AGENDA FOR THE REGULAR MEETING OF THE
MIDWEST CITY
PLANNING COMMISSION
November 3, 2020 – 7:00 p.m.
City Council Chambers
City Hall
100 North Midwest Boulevard

MINUTES OF MIDWEST CITY PLANNING COMMISSION MEETING

UTILITY PLAN

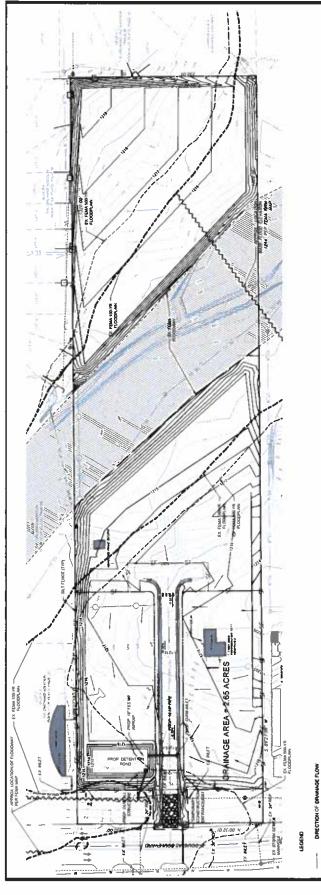
Section 38-18 in the Subdivision Regulations requires all existing and proposed utility lines and public improvements be reflected on the preliminary plat or accompanying plan. The proposed public utility line installations required with this application are shown on the plat, must be constructed and will be dedicated to the city prior to the final plat application. It should be noted that a fifty four (54) inch OKC water main runs along the eastern side of Douglas Boulevard. The developer cannot utilize this water main and may cause difficulty when crossing with proposed utilities. Caution during design and construction is advised.

Section 38-18 in the Subdivision Regulations requires all existing and proposed utility lines and public improvements be reflected on the preliminary plat or accompanying plan. The proposed public utility line installations required with this application are shown on the plat, must be constructed and will be dedicated to the city prior to the final plat application.

TREE CANOPY PLAN

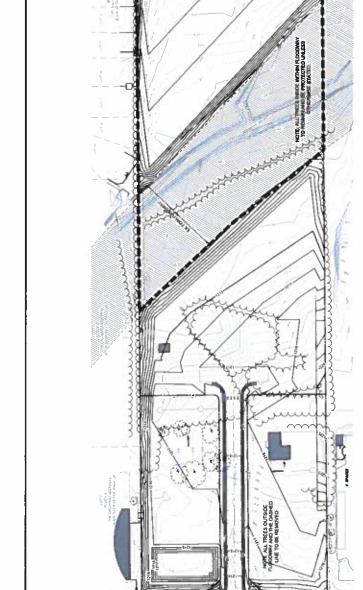
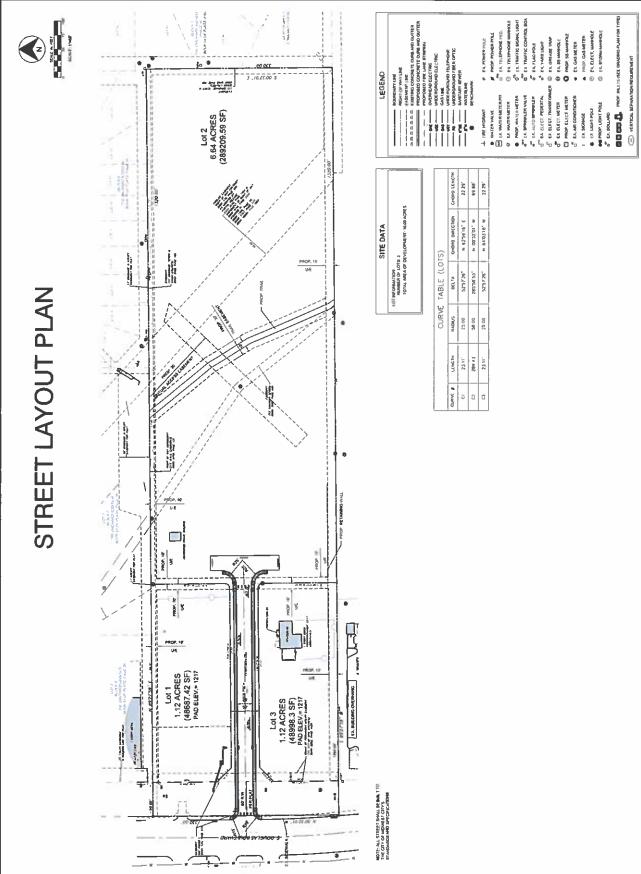
The applicant has submitted a tree canopy management plan as required by Section 38-53 of the Subdivision Regulations. The plan shows that all tress located within the floodplain and east of Soldier Creek will remain throughout the platting process. The applicant has submitted a waiver requesting to be allowed to remove some trees west of the creek that would be required to remain according to the Subdivision Regulations. The waiver request is included within the agenda packet.
